AMENDMENT TO OPERATING LICENSES NPF-4 AND NPF-7
NORTH ANNA POWER STATION UNIT NOS. 1 AND 2
PROPOSED TECHNICAL SPECIFICATION CHANGE

SAFETY EVALUATION FOR A REVISED $F_{\Delta H}^N$
 PART POWER MULTIPLIER
 FOR NORTH ANNA UNITS 1 AND 2
 OPERATION WITH A RCS TAVG OF 587.8°F

FIGURE 1

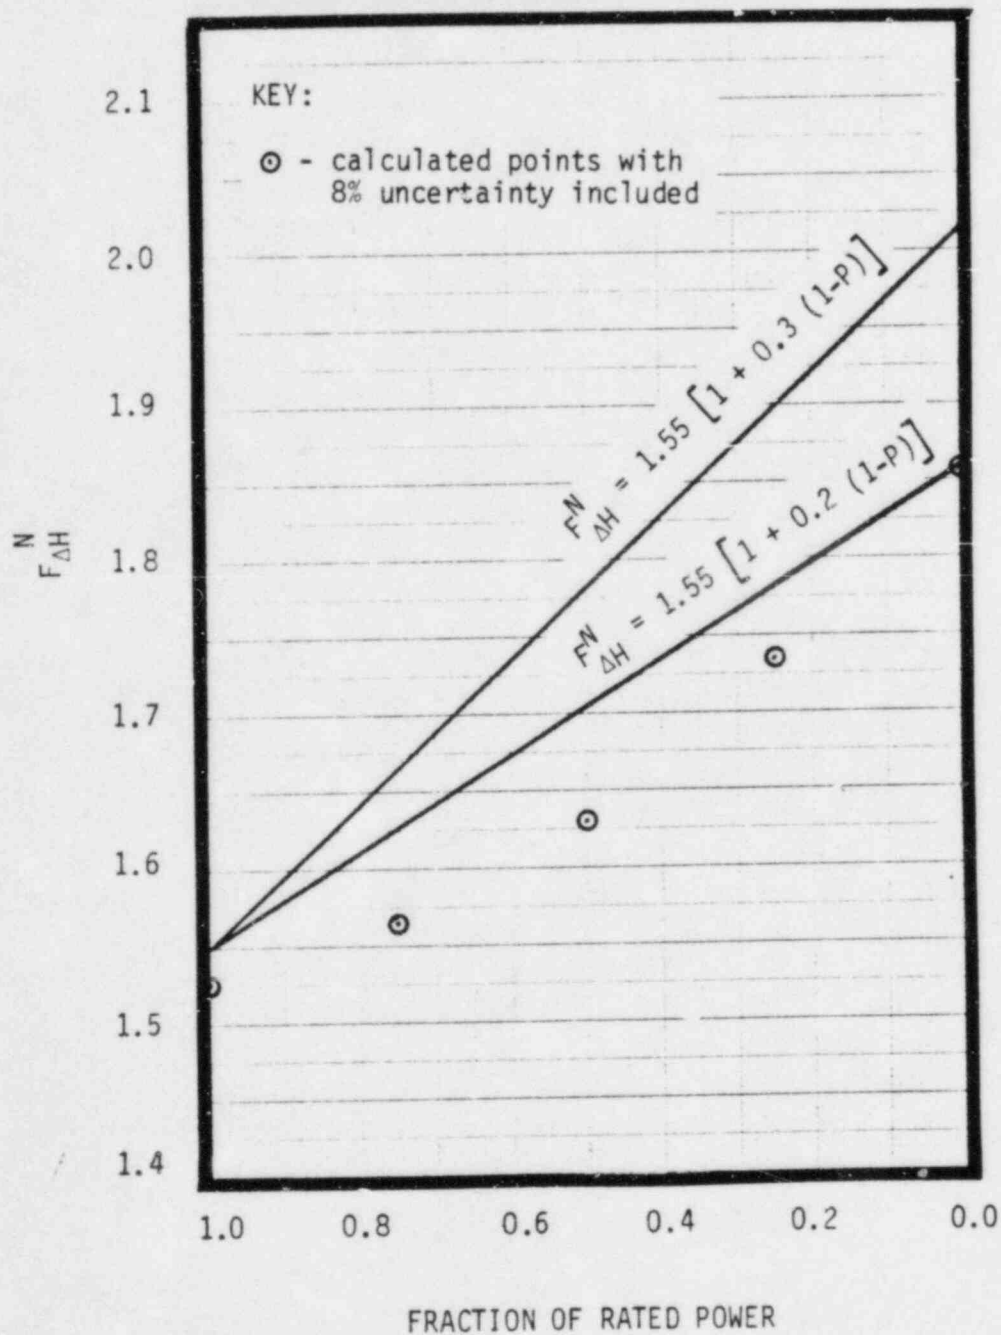
This change is requested for North Anna to allow optimization of the core loading pattern by minimizing restrictions on $F_{\Delta H}^N$ at low power. This change will also minimize the probability of making rod insertion limit changes to satisfy peaking factor criteria at low power with the control rod banks at the insertion limit. Figures 1 and 2 show the calculated values of $F_{\Delta H}^N$ versus core power for North Anna Unit 1 Cycle 4 and North Anna Unit 2 Cycle 3, compared to the current and proposed Technical Specification limits on $F_{\Delta H}^N$.

$$F_{\Delta H}^N = 1.55[1.0 + 0.3(1-P)]$$
